SERVICE BULLETIN

TR-7800

#828

SUBJECT: TR-7800 TONE PAD CONVERSION FOR 4th
COLUMN FUNCTION.

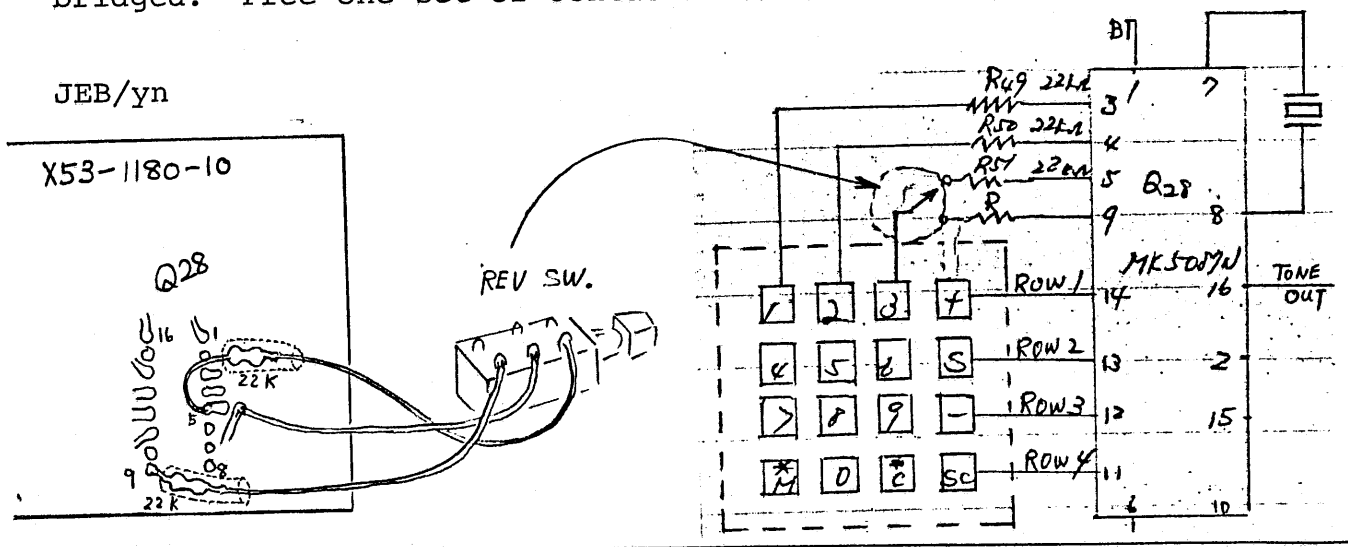
Users who desire ABCD control functions may be accommodated by an alteration to the Control unit and to the REV switch. This switch will then perform dual functions.

1. Remove top and bottom covers, 4 screws each.
2. To free the front panel, remove 4 screws securing the front panel bracket to the side frame.
3. Unplug 5 multiconnectors from the Control unit along the front and left edges of the board.
4. Remove 6 screws from the Control unit and swing the board over.
5. Remove and save R51 22k Ω located between IC's Q19 and Q28. (Q28 pin 5).
6. Resolder this 22k Ω resistor to Q28 pin 5, and solder another 22k Ω resistor to Q28 pin 9. Using a short piece of hookup wire, extend these connections to the REV switch as shown.
7. Connect a line from the center switch contact to the original feed point of R51, which is the B3 line.
8. To reassemble, reverse steps 4 through 1.

NOTE: This switch is a DPDT and may have both sets of contacts bridged. Free one set of contacts for this new function.

To operate the ABCD column, hold the REV switch IN and key the 3,6,9 or #keys. Normal 3rd column tones are supplied when the REV switch is not depressed. The receive REV function is not altered by this change.
